**Change of Specification for Boxes for Circuit Breakers (Water-proof type)**

We would like to inform you that we will change the specifications of boxes (Water -proof type) for Circuit Breakers as follows.

Boxes for Circuit Breakers (W Box)	Before	After
ex.) NFW-05SV  Bracket		 The screw holes are chamfered.

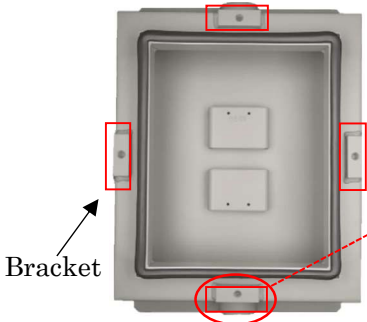
Add chamfering to the retaining plate for the cover fixing screws of the Boxes for Circuit Breakers (WBOX).
